Water Pump Base Cracked – 75 HP

Force/Tracker 1997 75 HP

USA 0E272933 thru 0E276907

a - Water Pump Base Plate
b - Front Area May Crack

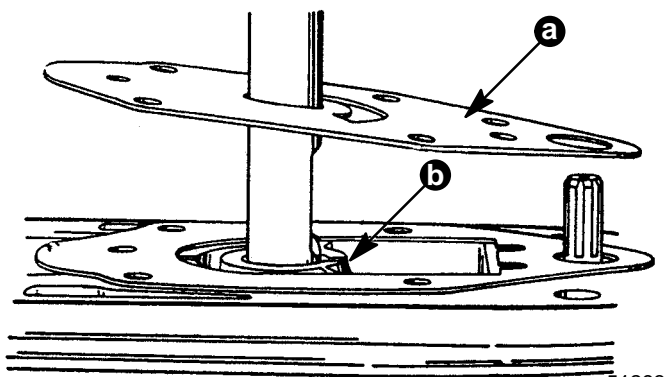
The water pump base on the models listed may crack and allow water to enter the gearcase causing a premature gear failure. Product previous to the serial numbers listed are not affected. The crack is caused by a combination of brittle material and incorrect clearance for the seal. A new water pump base p/n 46-812966A9 is changed in design and made of a more durable material to resist cracking.

a - Thermostat Cover

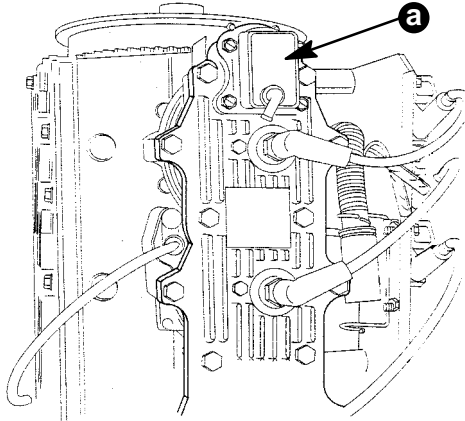
Install a new water pump base p/n 46-812966A9, install new water pump gaskets, pressure test, assemble lower unit to outboard, and identify that the outboard was repaired by placing a white paint dot on the thermostat cover.

Repair at the dealership should be marked with a white dot on the thermostat cover.

a - Pry Tabs

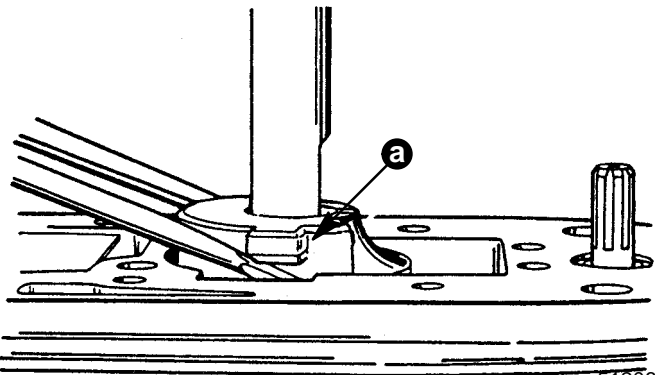
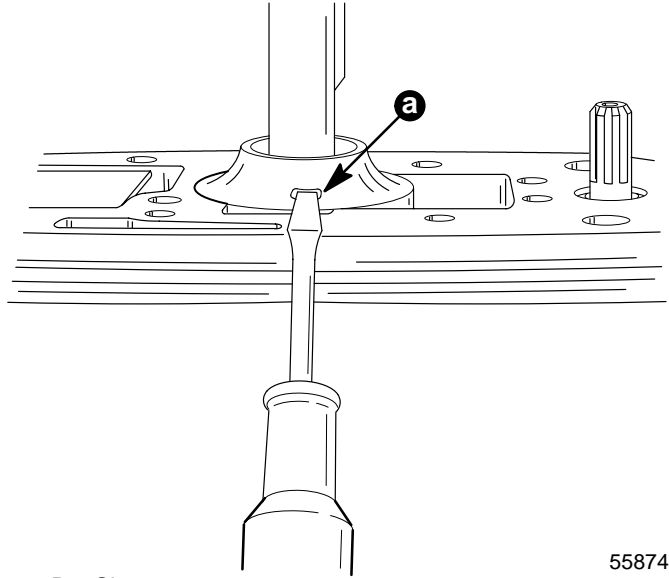
The previous water pump base p/n 46-812966A3 has a pry tab on each side to assist in removal from the gear housing.

The new water pump base p/n 46-812966A9 has a pry slot on each side to assist in removal from the gear housing. The slots must be positioned to the sides of the gear housing to allow for easy removal of the base if future servicing is required.

a - Support Mandrel.

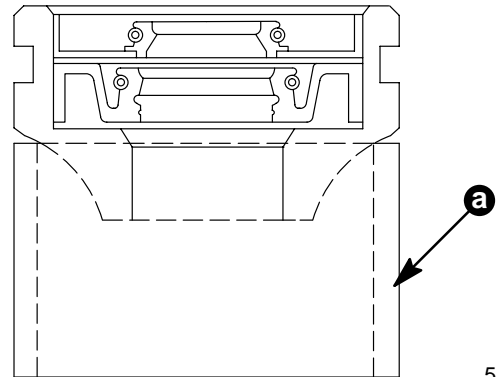
The water pump base must be properly supported on the outer edge when installing the seals into an empty base. The base is thinner on the outer edge of the seal area and breakage could occur if it is supported only on the center. Use a suitable mandrel that supports and contacts the outer surface of the base.
